JONES & BEACH ENGINEERS INC.

**RE: Response Letter 3 – Altus Engineering & TAC Comments
212, 214, & 216 Woodbury Ave., Portsmouth, NH, 03801
Tax Map 175, Lots 1, 2, & 3
JBE Project No. 21254**

We are in receipt of comments from Eric Weinrieb, P.E., Altus Engineering, dated October 25, 2022, and from Stefanie Casella, Portsmouth Planning Department, dated November 14, 2022. Review comments are listed below with our responses in bold.

SHEET 5 OF 23
JBE PROJECT NO. 21254

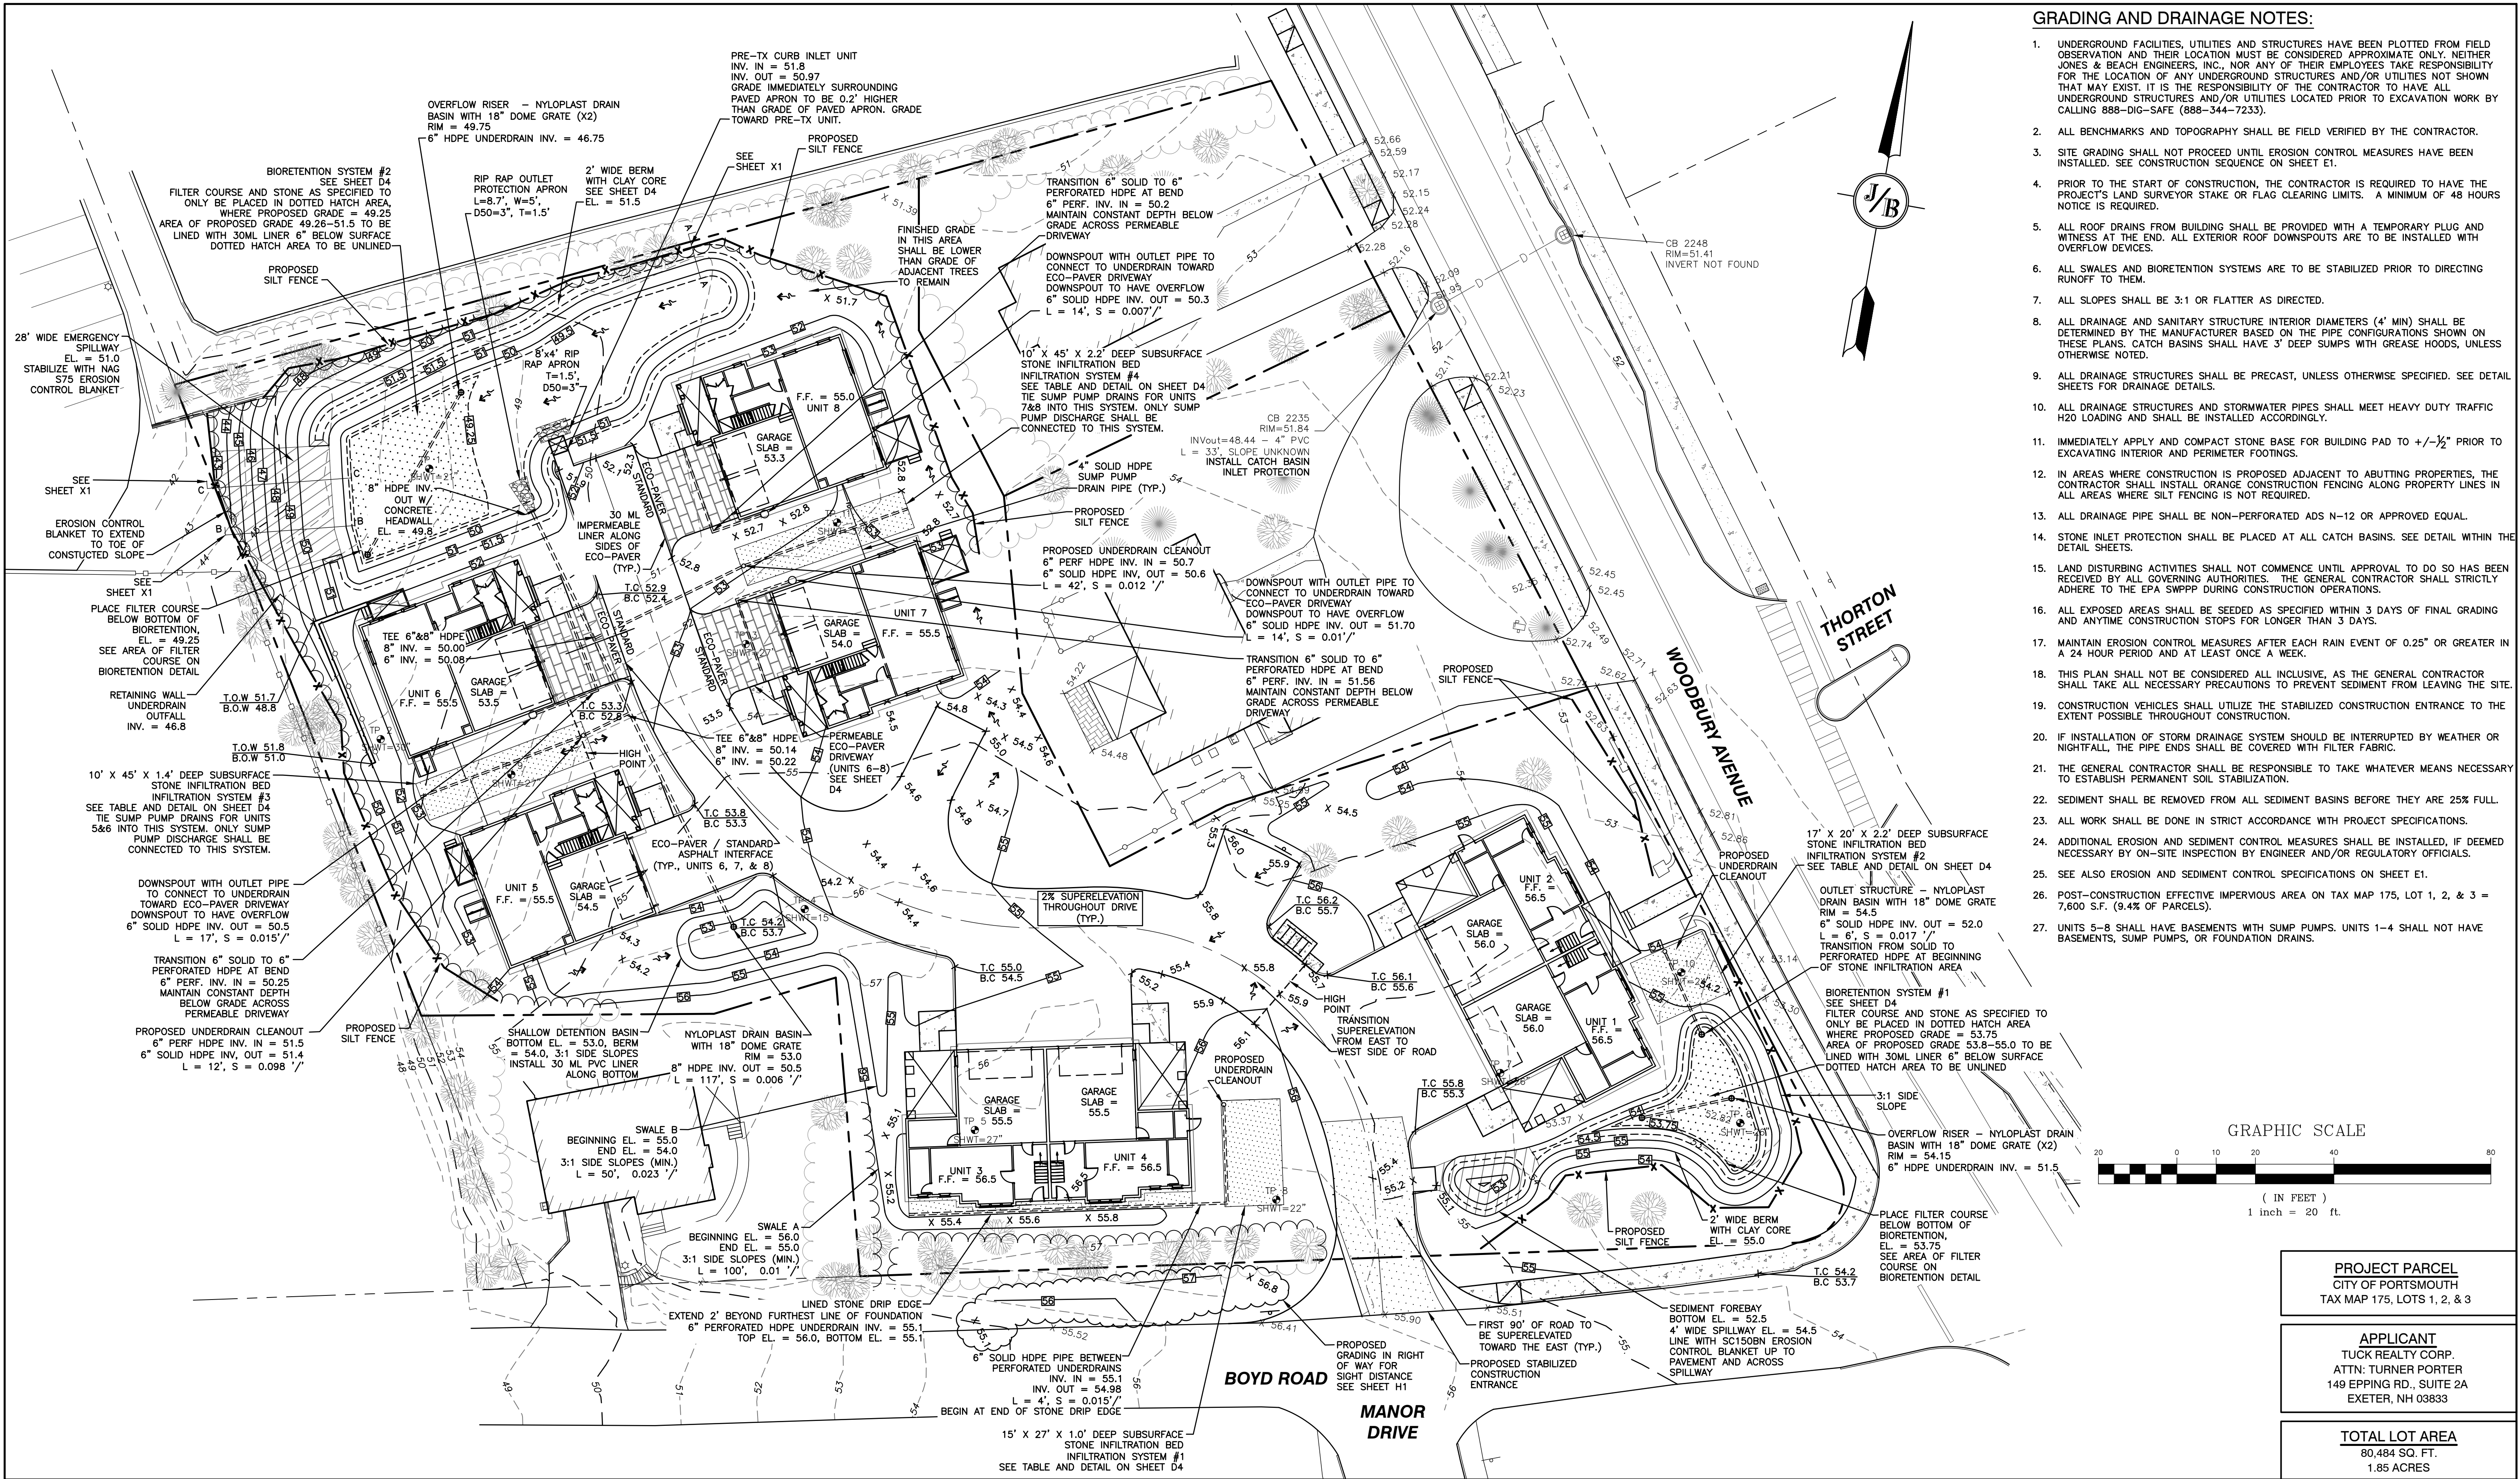
c) Notes should be added to the plans indicating that building units 1 through 4 will not have sump pumps or foundation drains.

RESPONSE: Note #29 on Sheet C2 has been expanded to indicate that units 1-4 will not have basements, sump pumps, or foundation drains.

DRAWING No.
C3
SHEET 6 OF 23
JBE PROJECT NO. 21254

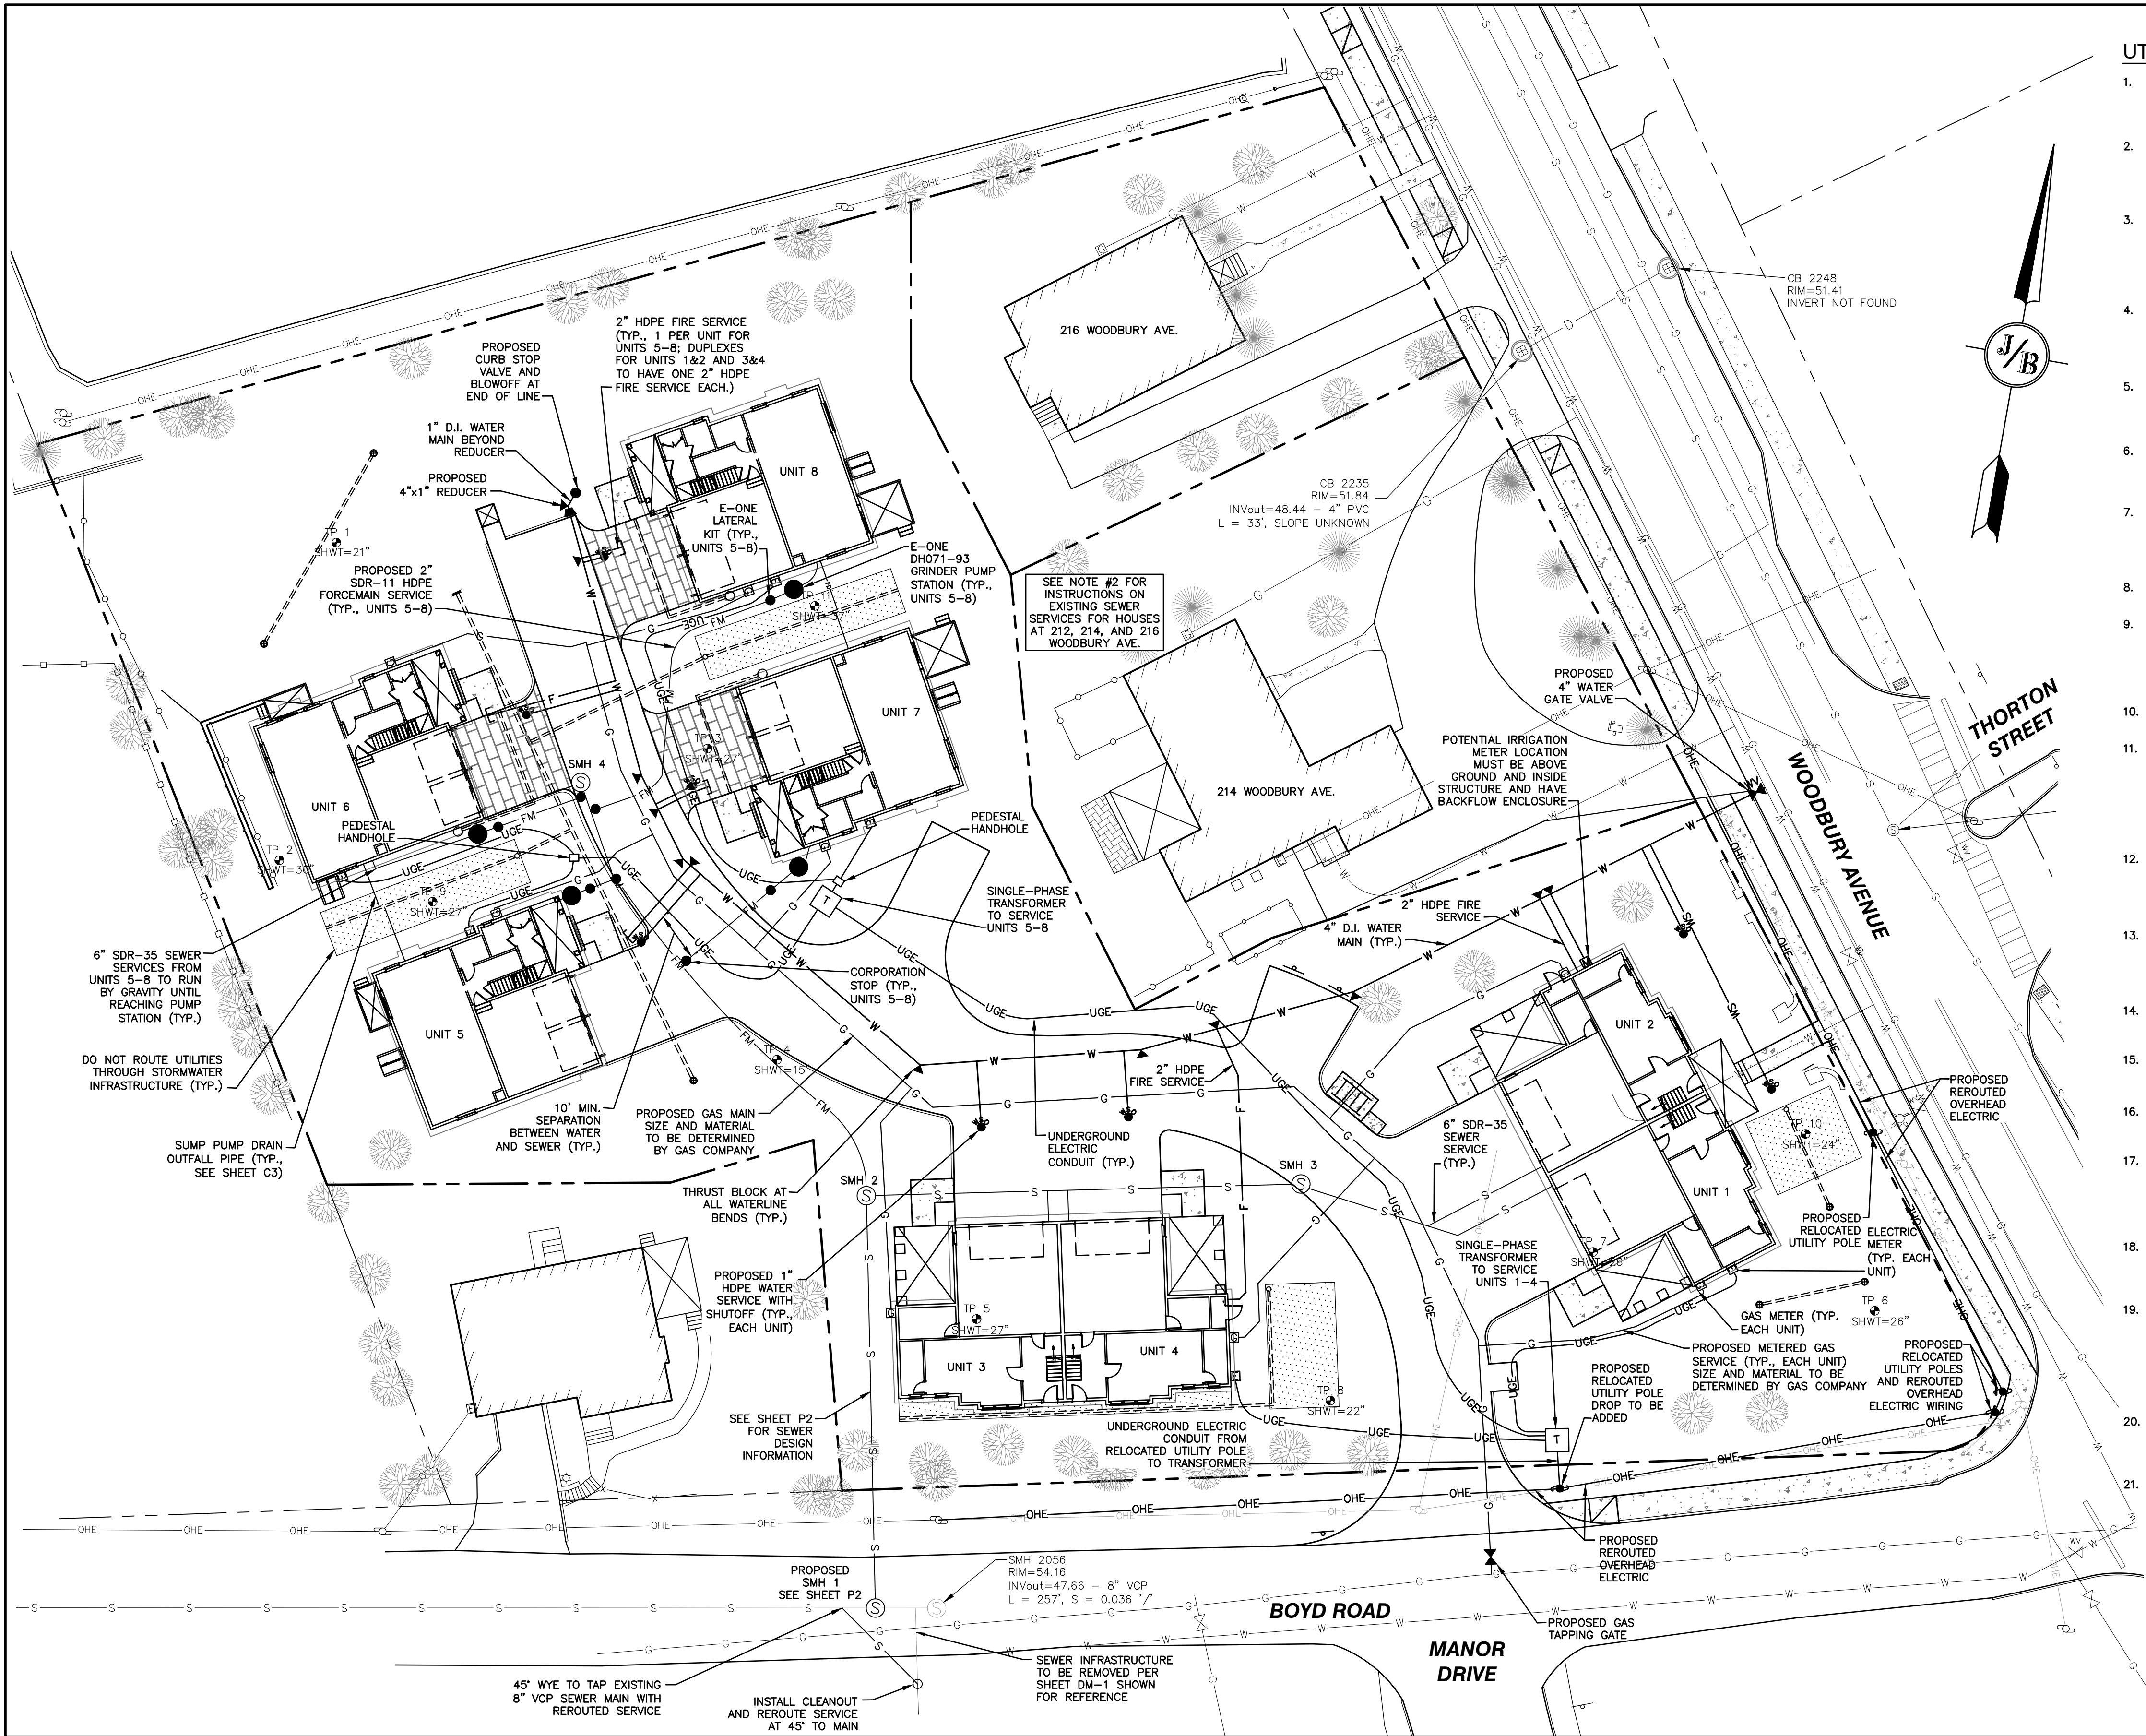
34. *The Designer needs to provide the calculation for the maximum effective impervious area for the development. Open issue. The Designer has indicated that the post development effective impervious will be approximately 2,000 SF. It appears that the Designer is not addressing the existing driveway and other built infrastructure that will remain. It is Altus' understanding that the regulations refer to all impervious on the site which is both existing to remain and new impervious.*

RESPONSE: The effective impervious calculation on Note #26 on Sheet C3 has been revised to include the existing impervious surface to remain on Lots 2&3.

25. SEE ALSO EROSION AND SEDIMENT CONTROL SPECIFICATIONS ON SHEET E1.
26. POST-CONSTRUCTION EFFECTIVE IMPERVIOUS AREA ON TAX MAP 175, LOT 1, 2, & 3 = 7,600 S.F. (9.4% OF PARCELS).
